# SERVICE LETTER

No. 815

Piper Aircraft Corporation

Subject: Radar Antenna Mounting Plate Inspection and Modification

SKETCH "A"

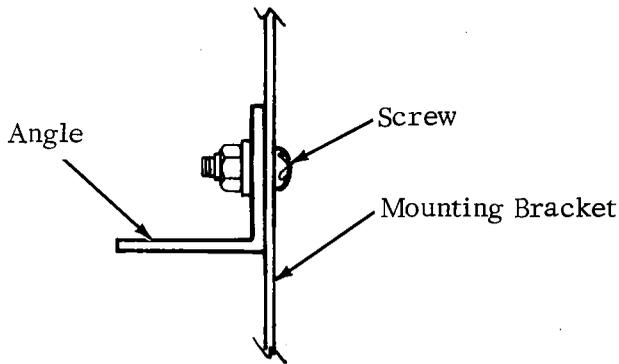
Purpose: It has been brought to our attention that, under certain conditions, the Bendix RDR-150 Radar installed in the above referenced aircraft may not display an accurate weather outline on the instrument panel mounted indicator. It has been determined that this condition can be caused by the radar antenna mounting plate "flexing" during turbulence, distorting antenna scan.

This Service Release contains instructions to inspect the antenna mounting plate to determine the type of plate installed, and, if necessary, to reinforce or replace the plate to provide a rigid radar antenna mounting surface.

Drill .156 hole (in mounting plate)  
 Screw - MS35206-227  
 Washer - AN960-6  
 Nut - MS20365-632C  
 (8 req.)

Fabricate Angles  
 Per Figure 1

Existing Bolt - AN4-3A  
 (4 req.)  
 (.250 hole in Angle to  
 match .250 hole in  
 mounting bracket)

- a. MODIFICATION OF EXISTING BRACKET: (Refer to Sketch "A").
    - (1) Remove radar antenna drive unit mounting bracket from airplane.
    - (2) Fabricate two angles per Figure 1.

- (3) Locate and drill (4) .156 holes and (2) .250 holes in each angle per Figure 1.
    - (4) Locate and drill (8) .156 holes in mounting bracket, as shown using the two angles fabricated in step (2) and (3) as a template.

- (5) Attach the two angles to the mounting bracket using hardware as shown on Sketch "A".
    - (6) Reinstall mounting bracket assembly to bulkhead using existing hardware for attachment.

FIGURE 1  
 Angle Detail

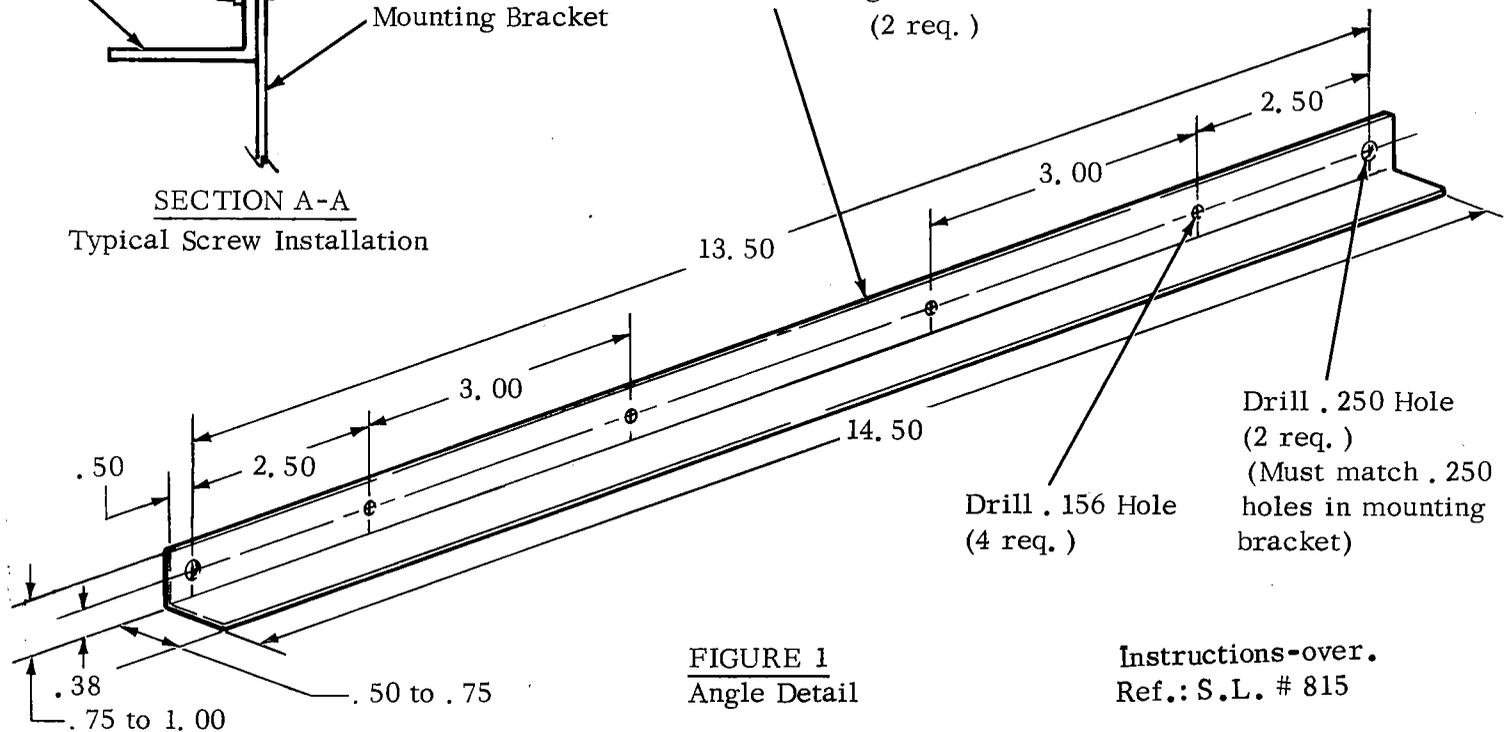
Pre-Formed Angle - .063 2024-T4 Alum.  
 or  
 Fabricated Angle - .063 2024-T3 Alum.  
 (2 req.)
